CHURCH AT BENT GRASS MEADOWS CONSTRUCTION DRAWINGS

PCD FILE NO.: SF268

CONSTRUCTION DRAWINGS
PUBLIC ROADWAY IMPROVEMENTS

DETAIL A - PUBLIC SIDEWALK AND ADA ROUTE

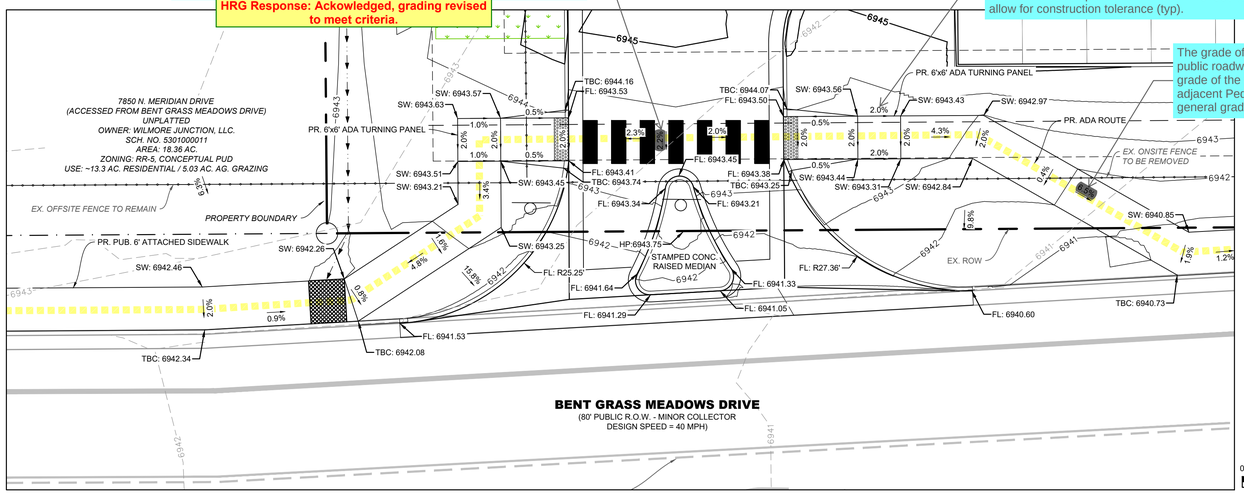
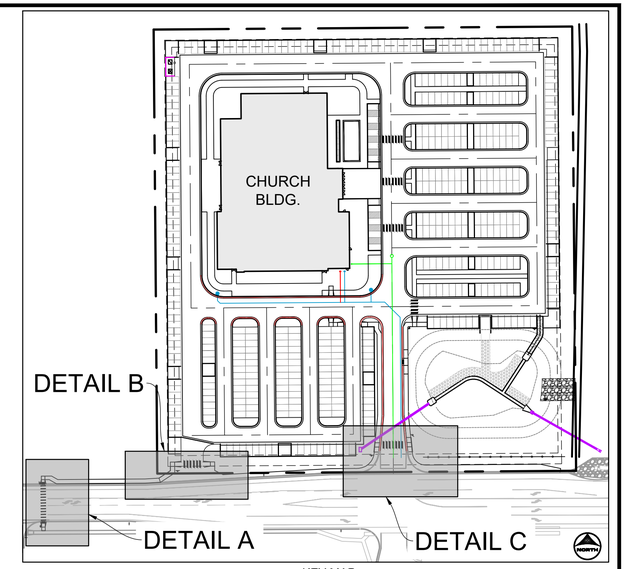
The cross slope of a pedestrian street crossing at an intersection with yield or stop control that is within the Pedestrian Access Route shall not exceed 2%. A cross slope of 1.8% is recommended for design to allow for construction tolerance.

Note: The cross slope of all sidewalk contained within the pedestrian access route shall not exceed 2% Typical sidewalk cross slope of 1.5% is recommended for design to allow for construction tolerance (typ).

The grade of Pedestrian Access Routes within and adjacent to public roadways shall not exceed 5%. When, however, the grade of the adjacent street is greater than 5%, the grade of adjacent Pedestrian Access Routes shall not exceed the general grade of the adjacent street or highway.

HRG Response: Ackowledged, grading revised to meet criteria.

HRG Response: Acknowledged, grading of cross slope revised in this area.

HRG Response: Sidewalk adjusted for more length to achieve 5.0% longitudinal slope.

HRG Response: No longer an ADA route, see revisions to ADA route on SDP and this plan set. Sidewalk removed here.

HRG Response: This is private sidewalk adjacent to private drive, we can have longitudinal grades up to 8.33%.
